Field Change Order Number: 00-AS800 F001
Field Change Order Name: ASR800 Combo Slot –12v issue
Customer Document Number: EK-COR64-CL

Field Change Order Instructions

Subject: AlphaServer 800 64-bit PCI slot restrictions

Figure 1

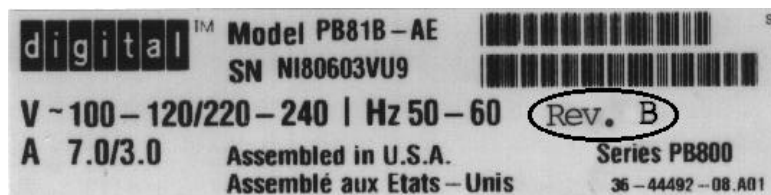
Digital has redesigned the system module to correct the problem and our manufacturing plants are now shipping only AlphaServer 800 systems that have this design change implemented. You can quickly determine if your system is affected by reading the revision of the system on the model number label on the back of the system enclosure. The systems that have had this problem corrected are marked with a Revision B or later. An example of the Revision B system label is shown in Figure 1 (see oval; the location of the revision text may vary). Any system that does not have a revision letter on the label is considered a Revision A and is affected by this problem.

Figure 2

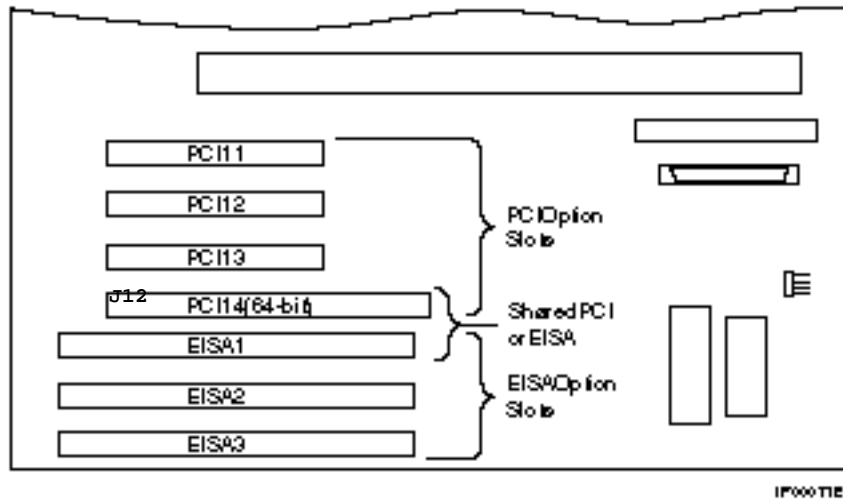
We suggest that as a precautionary measure, customers apply a piece of non-conductive tape across the top of the 64-bit PCI slot to inhibit installation of option modules. The affected 64-bit PCI slot can be identified by the legend “J12” marked adjacent to the 64-bit PCI connector on either variation of the system module. See Figure 2 below.
